<b>SLA</b> <b>Document</b> <b>COS-002</b>	<b>SilverLight Aviation</b> 40420 Free Fall Ave, Unit A Zephyrhills, FL 33542. USA info@silverlightaviation.com	<b>Service Bulletin</b>	
		<b>Release Date:</b> <b>05 / 29 / 2018</b> <b>Effective</b> <b>Date:</b> <b>05 / 29 / 2018</b>	<b>Notice # 004</b> Superseded Notice # __ <i>(if applicable)</i>  Page 1 of 12
<b>Limitations for completion of any required corrective actions:</b>  <b>Any time - Optional</b>		<b>Affected Aircraft</b> Make and Model: AR-1  Aircraft Serial Number(s): 0001 - 0022

## Optional Upgrade of Pitch Trim System

Improvement and upgrade of AR-1 pitch trim system for better functionality

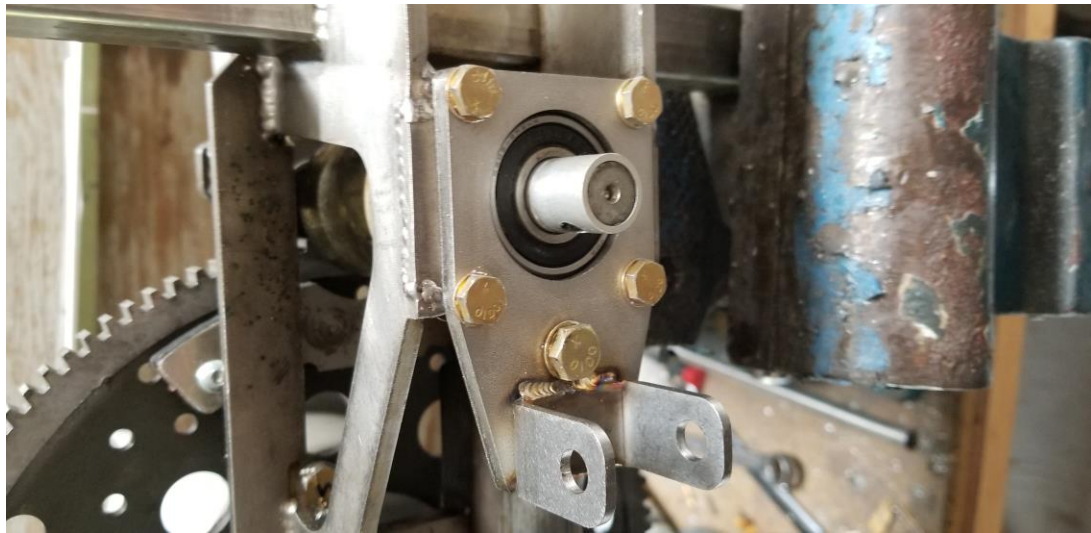
11) Screw on the new modified trim shaft into black actuator body. Secure tight
